Re: Mesa del Sol Tract A - Mixed-use Multifamily DFT Comment Response

The letter outlines the project team's responses to the comments from the May 3, 2023 meeting of the Development Facilitation Team on PR-2023-008551 SI-2023-00778 Site Plan DFT for a mixed-use multifamily development on Mesa del Sol Tract A. The DFT comments are in bold, and the responses are in italics.

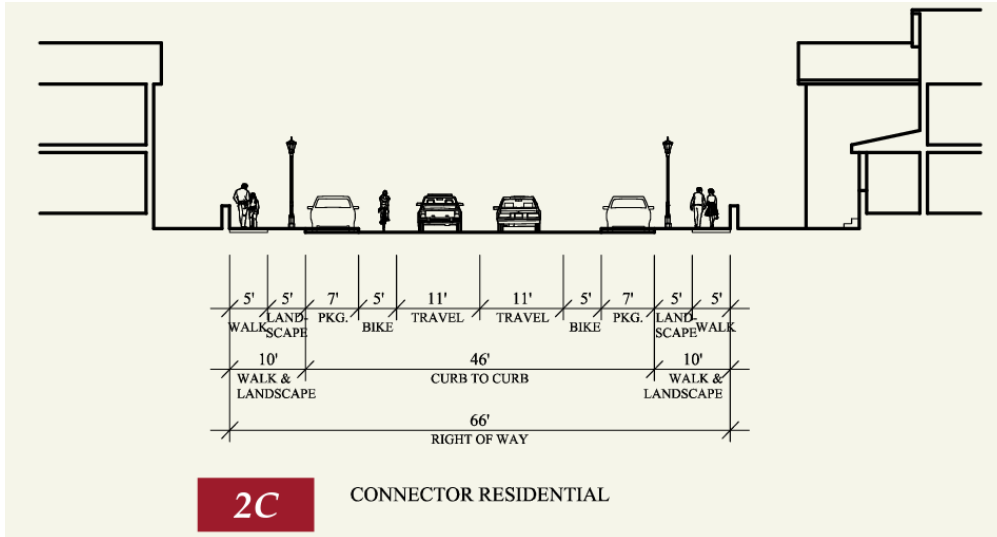
Clarify the bike path indicated on the site plan. Will this be a bike lane or a multi-use trail?

The bike path indicated on the site plan is a bicycle lane within the public right-of-way, as indicated on the street sections shown below.

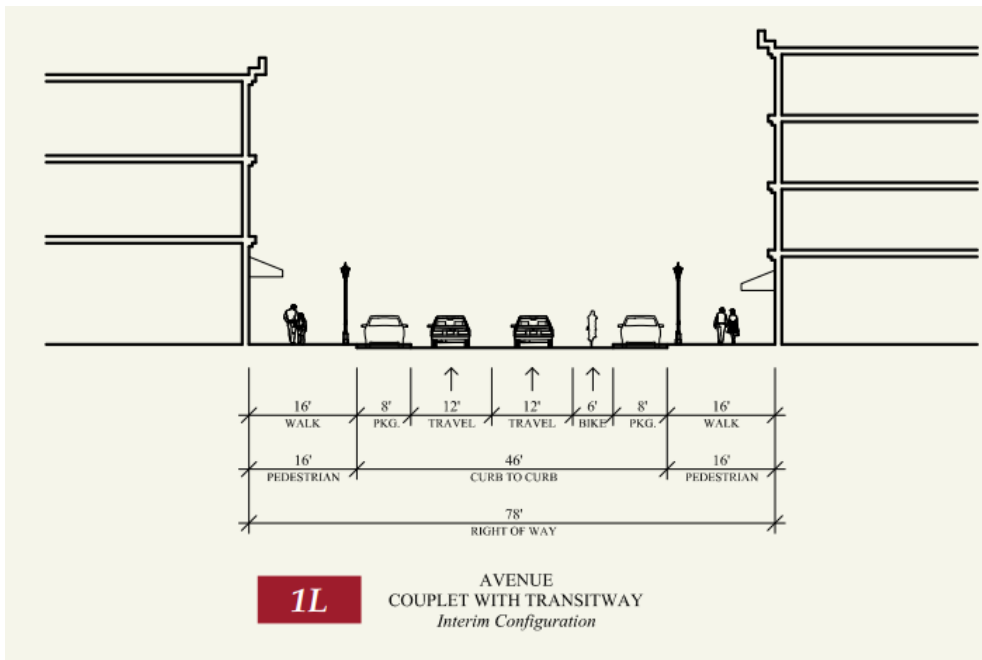
All surrounding roadways are proposed arterials and within a center, please ensure all sidewalks along exterior roadways are 10' with a 6-8' landscape buffer. I only see sidewalk width called out on West University and North Mesa Del Sol, but no buffers.

Roadways surrounding the site are governed by the Mesa del Sol (MdS) Level A and Level B Plans and the associated technical appendices and by the IDO and DPM where these are silent.

The MdS Level A Plan includes street sections in Chapter 3 Transportation. These sections define the required roadway configurations for the streets surrounding the subject property. These sections provide a different pedestrian realm configuration than the 10' sidewalk and 6-8' landscape buffer listed in the provided comment and in the DPM. These standards supersede the DPM requirements and are shown below.

Stryker Road and Dekooning Ave are required to provide a roadway configuration that meets the 2C Connector Residential section shown below, taken from page 41 of the MdS Level A Plan. Dekooning Ave is already constructed, and the proposed site plan would not alter the configuration of the existing roadway. A portion of Stryker Road is already constructed. The proposed improvements would match that existing section and conform to the geometry listed in the section below.

University Blvd and Mesa del Sol Boulevard are governed by the 1L Avenue Couplet with Transitway Interim Configuration, taken from page 40 of the Mesa del Sol Level A Plan.

The proposed road improvements will comply with the requirements of the Mesa del Sol Level A Plan by providing pedestrian realms that comply with the sections shown above.
